## Madera Unified School District

Addendum No.1.1

This addendum is attached to and made a part of the above-entitled specifications for Madera Unified School District for:

### **Clarification/Questions:**

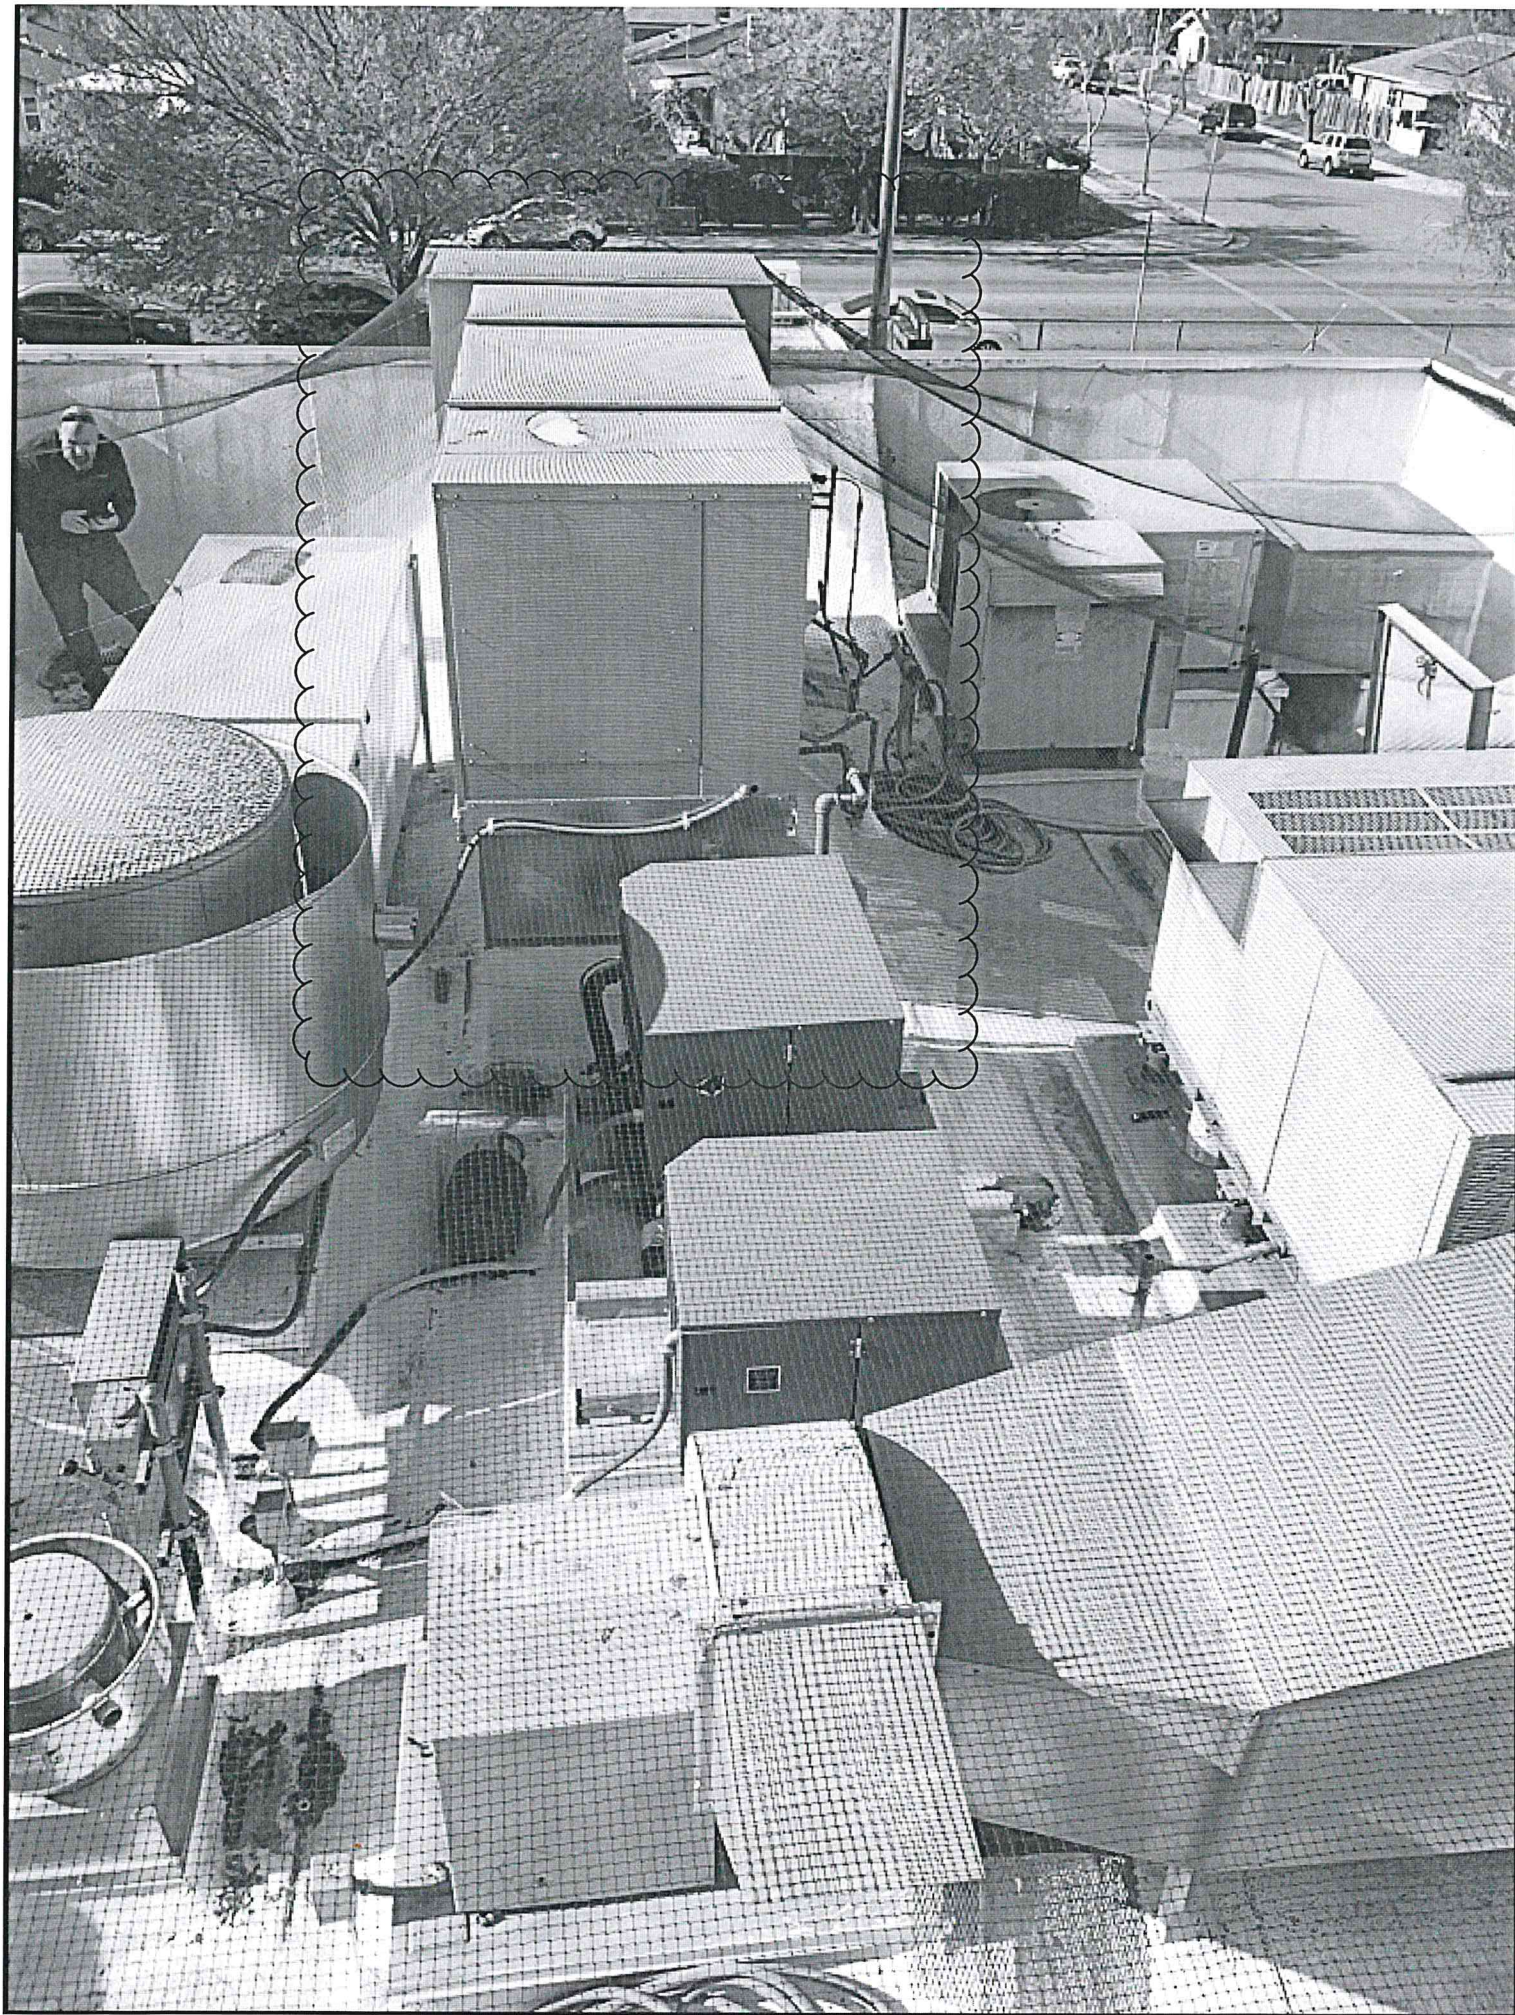
Sheet M510 keynote 4 for Martin Luther King Middle School states to remove the existing MAU and curb to be replaced with new. Detail 2/M800 goes to show a brand new curb roofed in and with possible new blocking under the existing roof. All other units on this job are using existing platforms to avoid demo and patch back of the existing roofing. If we follow this detail, roofing work will be required, which might be difficult given how tight of a space this unit is located in with relation to other units (see attached picture). We would recommend installing an adapter curb to avoid disturbing the roof or surrounding units.

Please clarify if the intent for MUA-25 is to peel back the roofing, install new blocking, and patch back roofing as implied by the detail.

Contractor is to install (N) Make-Up Air Unit and (N) curb per plan and Detail 2/M800.

DATE: 05/13/2024  
SHEET TITLE:  
**MECHANICAL  
ROOF PLAN -  
EAST GYM**  
SHEET NO.:  
**M501**

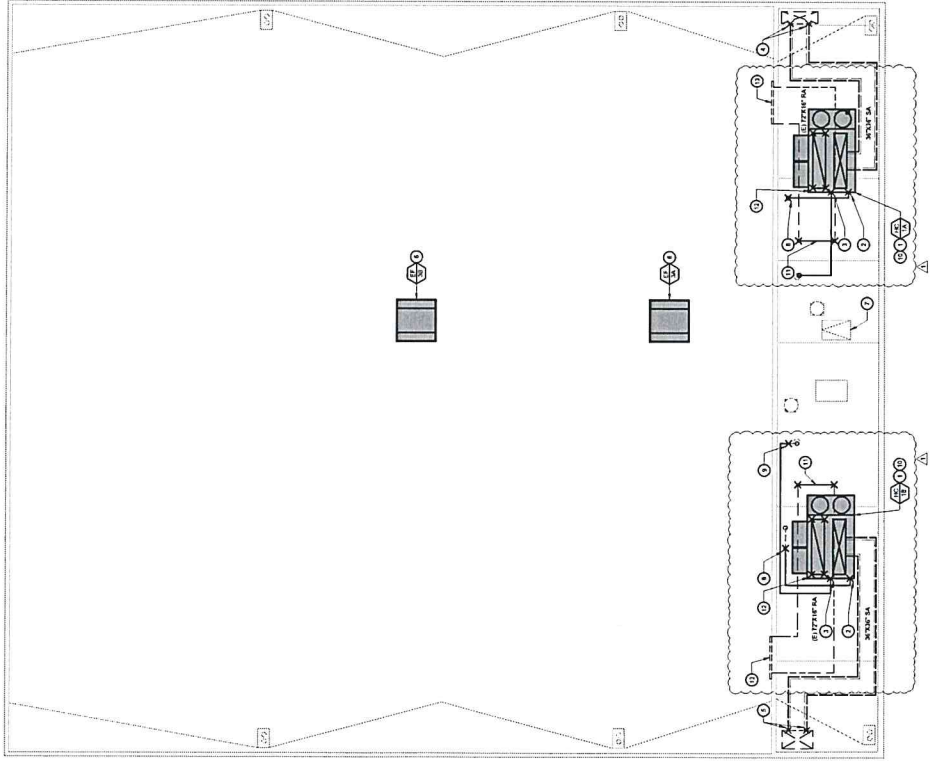
Sheet M501 shows two new 40x38 wall penetrations into the gym. Please provide a detail for this wall penetration/sleeve. In addition, specify the grille and/or louver to be used for the RA duct termination in the gym.

Sheet M501 shows no new roof duct supports for the east gym roof duct. Sheet M520 shows no new roof duct supports for the locker room roof duct. Please clarify if roof duct supports will be needed so all contractors bid the same.

The East Gym units have existing 72"X16" RA ducts routing to existing penetration with existing grilles. Refer to the updated sheet M501 for connection of new RA drop to existing RA duct.

The new duct work on sheets M501 and M520 drops through the roof directly below the unit. No new rooftop duct work is required.
